Booster Cavity Installation Meeting 4 7 2016

Minutes: (Halinski, Meier, Tuozzolo, Brutus, McIntyre, Phillips, Than, Soria, Nayak)

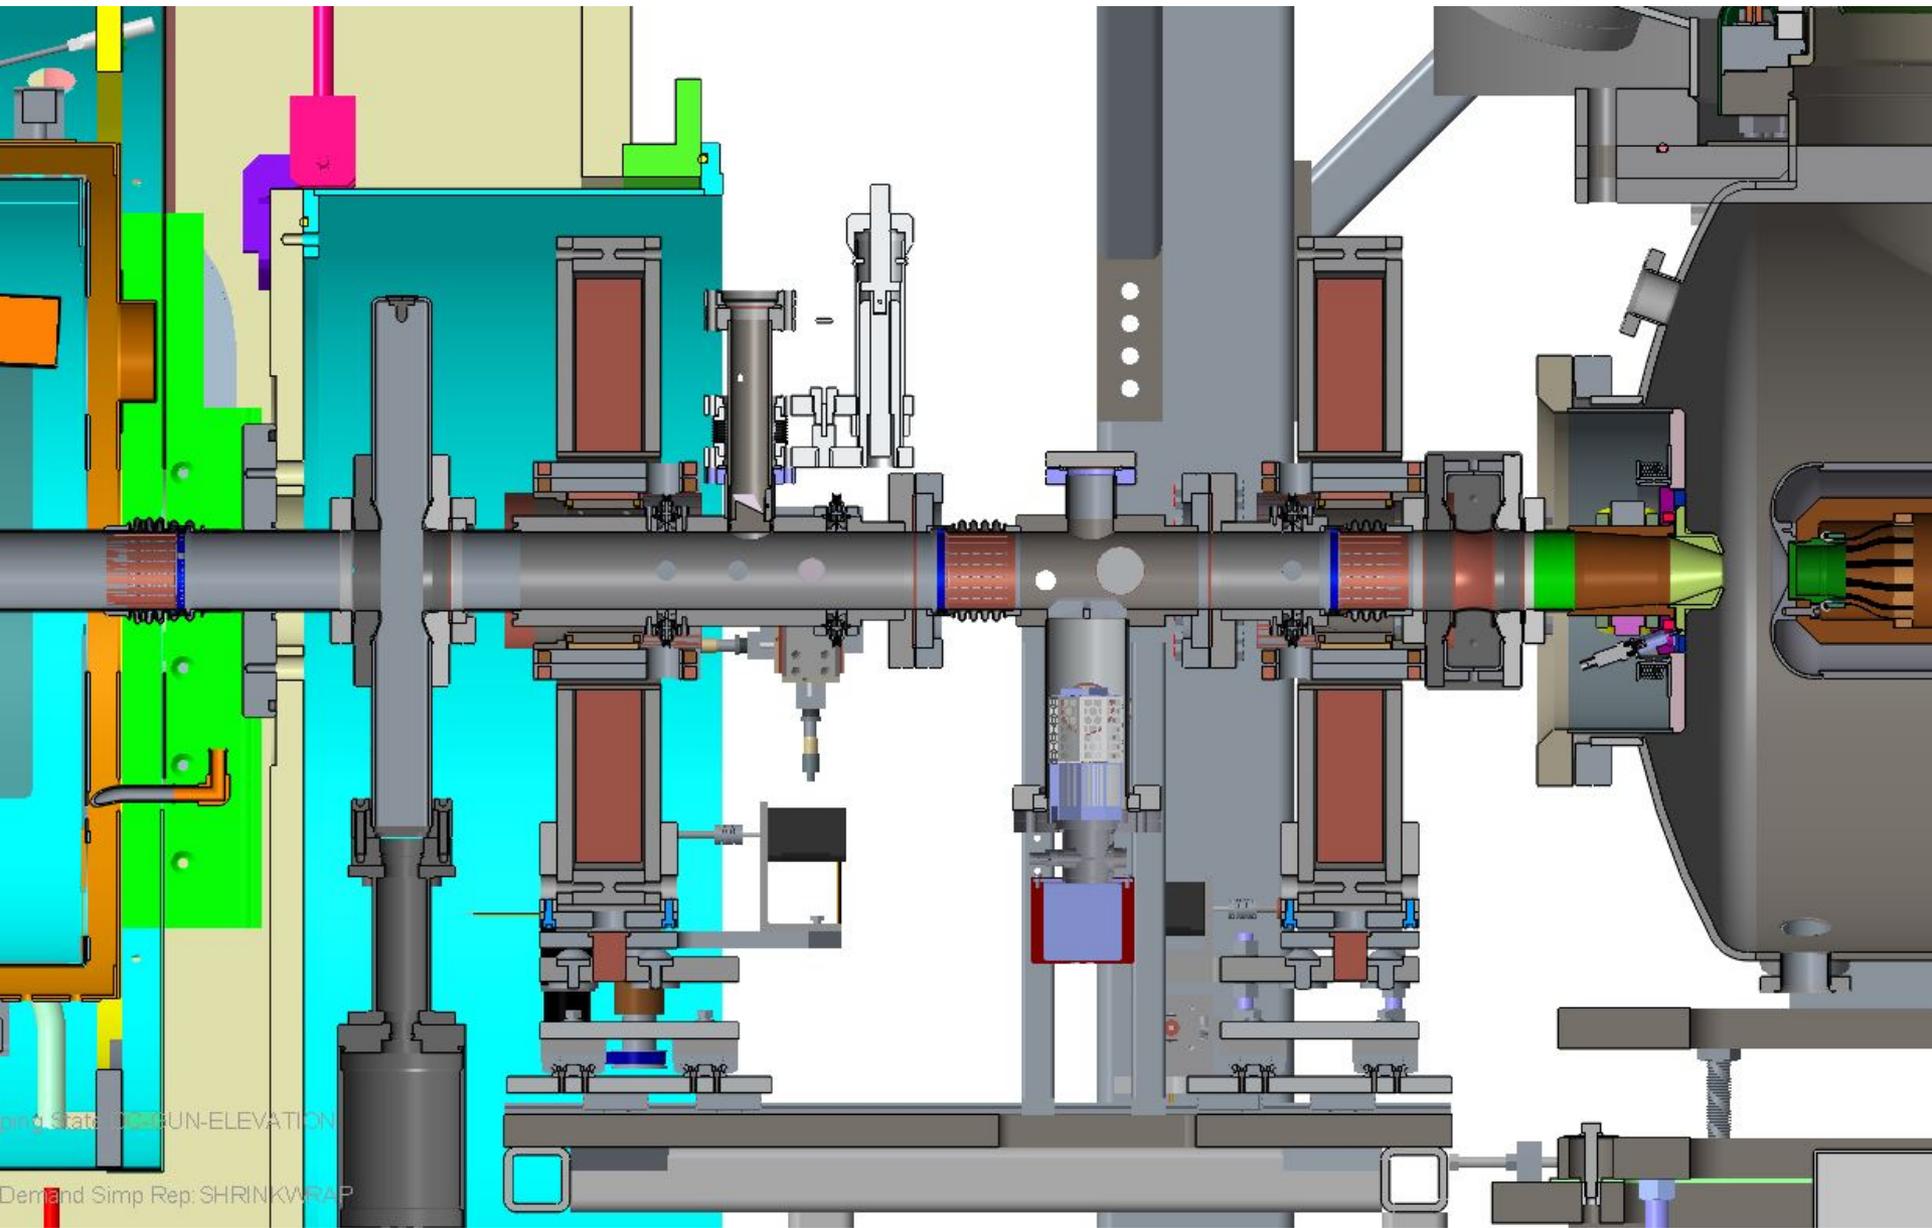
- Bob Meier will continue to work on completing the cryogenic line specification control drawings.
- There was discussion on the downstream end of the Booster cavity shown in slide 5. The coax beam tube size is determined by RF needs for the HOM (Binping) so a reducer is needed. G. McIntyre will check if the reducer can be installed at the HOM before the downstream end flange to save beam line space.

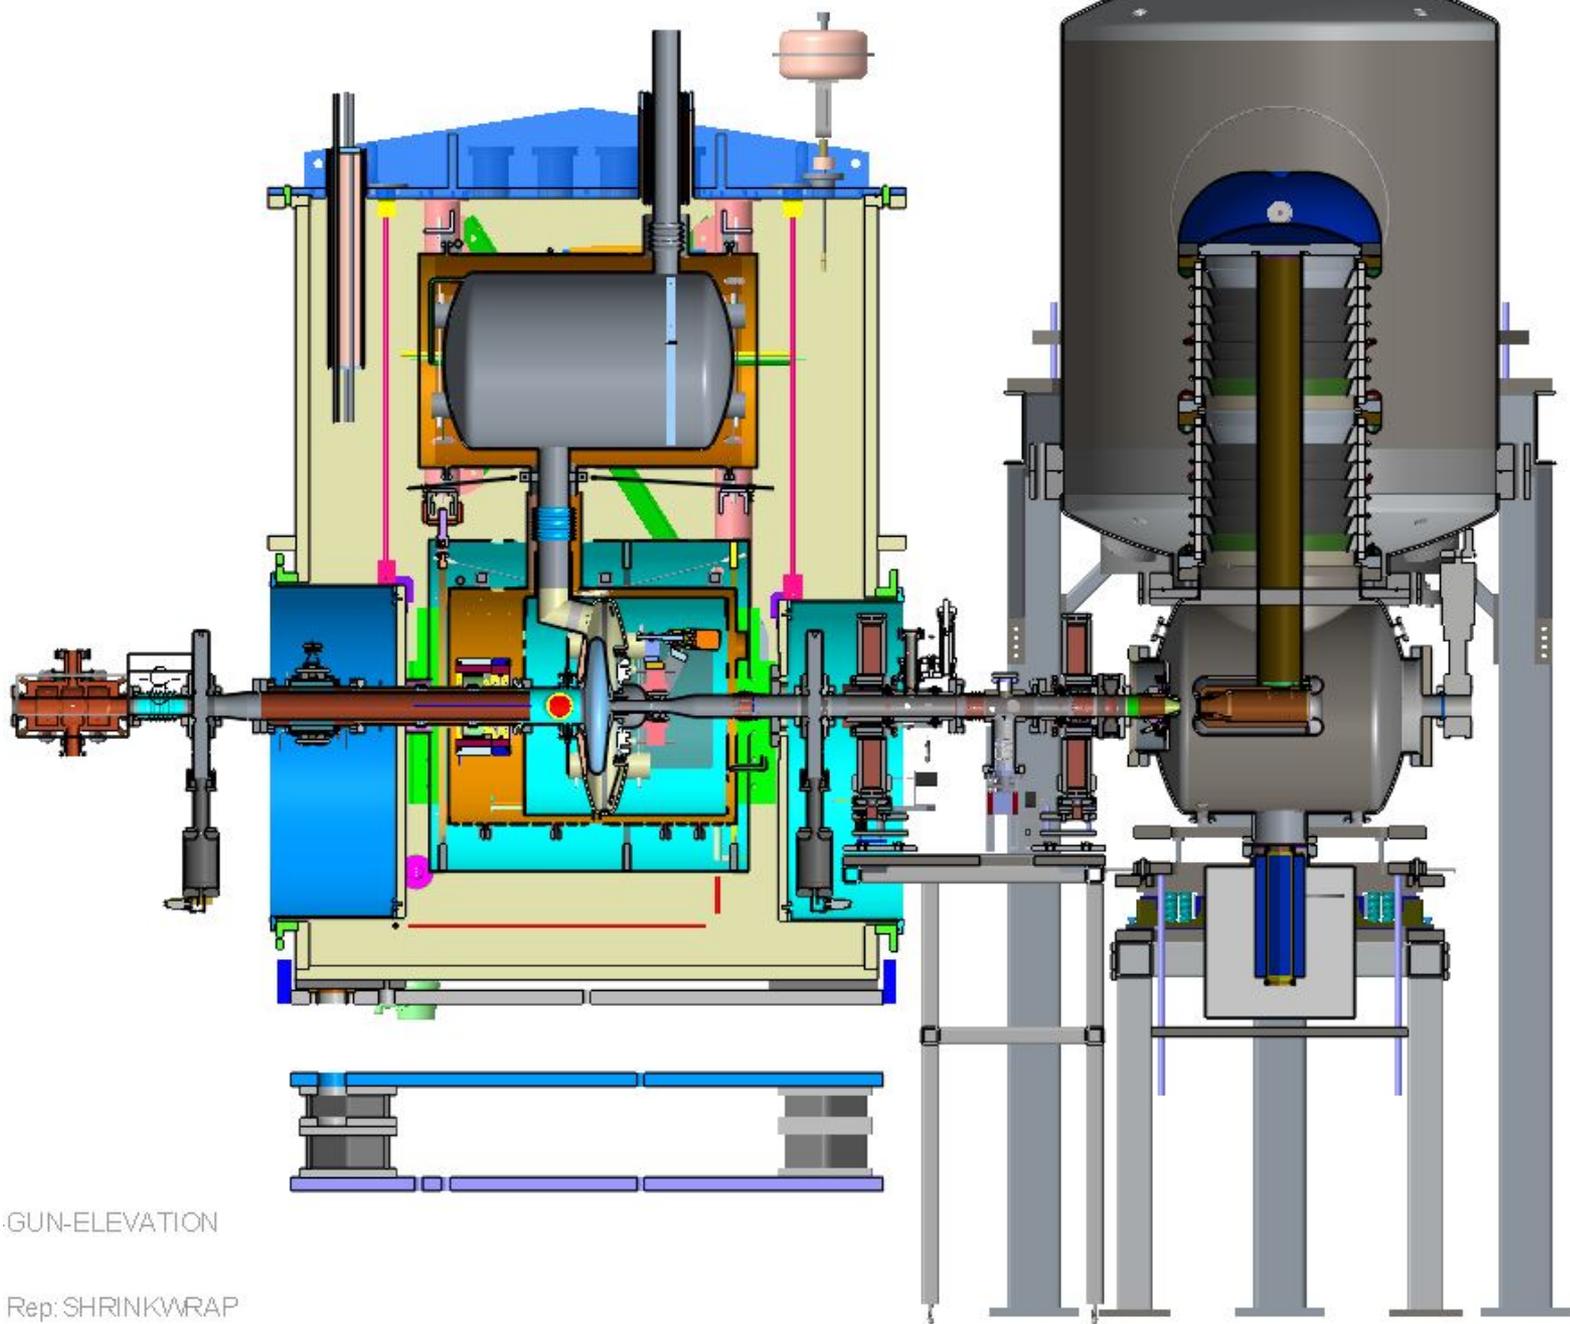
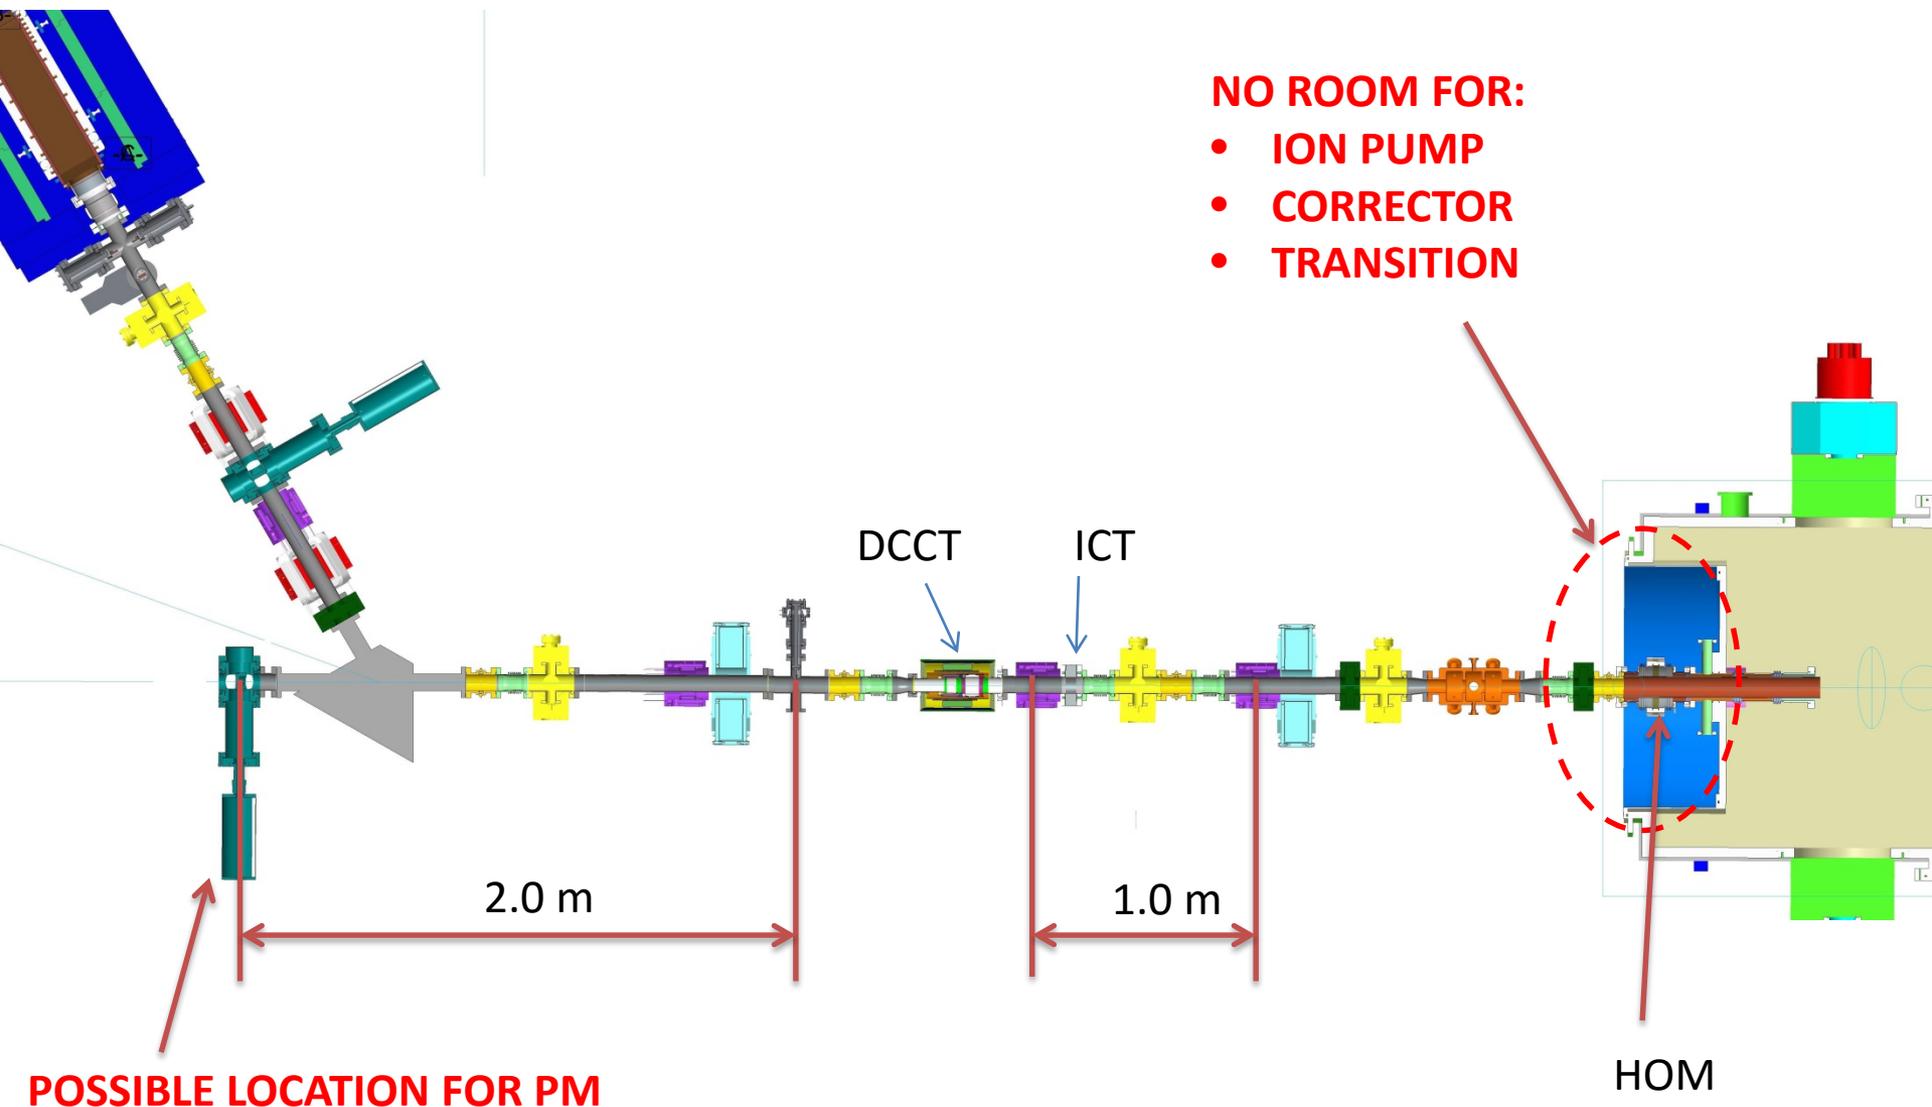
As I understand the PM emittance measurements monitor could be pushed behind the magnet and no one screams about it. Greet.

1. Please correct me if I'm wrong but in final configuration (2017) there will be pumps as part of booster assembly. May be it will be enough.

Do we need additional pump between booster and 3rd harmonic cavity in this case? **This should be verified by vacuum group.**

1. For gaining more room we could put correctors around bellows or/and around transitions.
2. For the same reason could we use profile monitor cross and/or slit cross to attach pumps instead of stand alone ports?
3. If there is room behind gun. One of the option could be to move booster and gun as one piece from the 3rd harmonic cavity and clear this area.
